Historic Alexandria Resources Commission

September 19, 2022

Re: BAR #2022-00175 PG Samuel Madden Homes

Statement Regarding 899 and 999 North Henry Street BAR Case #2022-00175, July 20, 2022
Presented on behalf of the Historic Alexandria Resources Commission by Chairman Danny Smith

Figure 8: Variation in massing height and depth

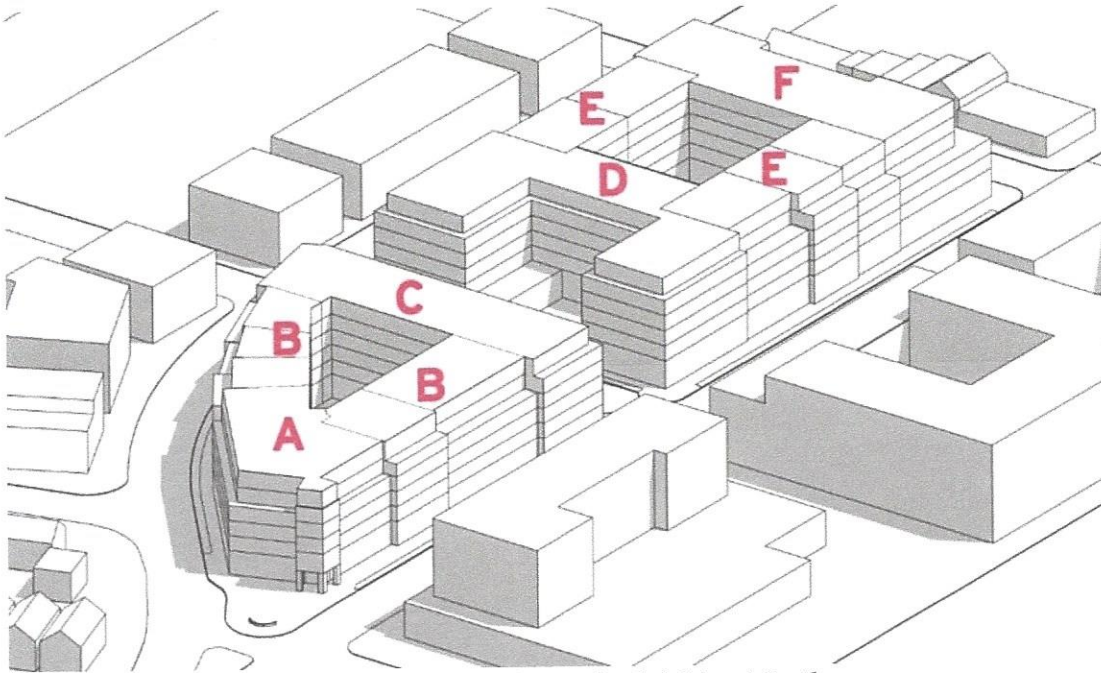
At the last hearing, Board members expressed concern regarding the homogeneous height of building shoulders and the setbacks for upper levels, stating that this consistent height contributes to a feeling that the building is too large for its surrounding. The applicant has addressed this comment by identifying specific locations on the building that respond to adjacent buildings or viewsheds and varying the massing in these locations. As shown in the submitted documents, the proposed design includes a rhythm of massing types with a variety of height and depths for the upper level setback areas. This rhythm breaks up the overall massing, including the roofline, to approximate a rhythm found elsewhere in the historic district (Figure 8).
